CMAC/HMAC-Digest Generation Method using the EIK

Seokheon Cho, Taeyong Lee, and Chulsik Yoon

ETRI

Figure 136-HMAC/CMAC authentication key derivation from EIK

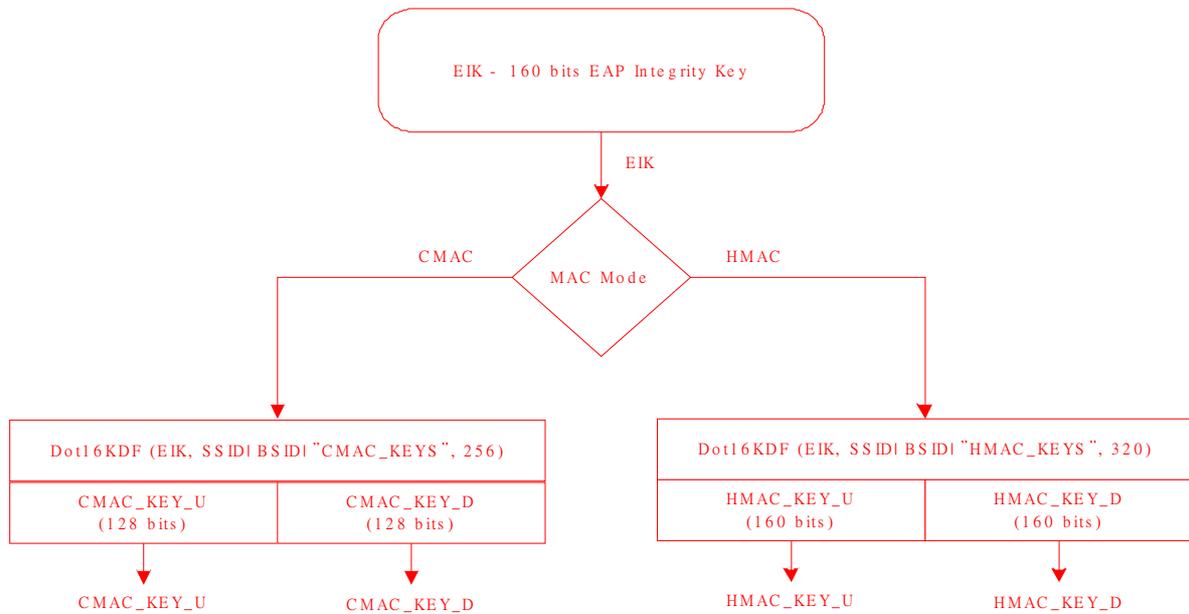
[Add following contents below Figure 135 in sub-clause 7.2.2.2.10]

Figure 136 outlines the process to calculate message authentication keys derived from the EIK. The message authentication keys are used to generate the CMAC value or the HMAC-Digest included in a PKMv2 Authenticated-EAP-Transfer message.
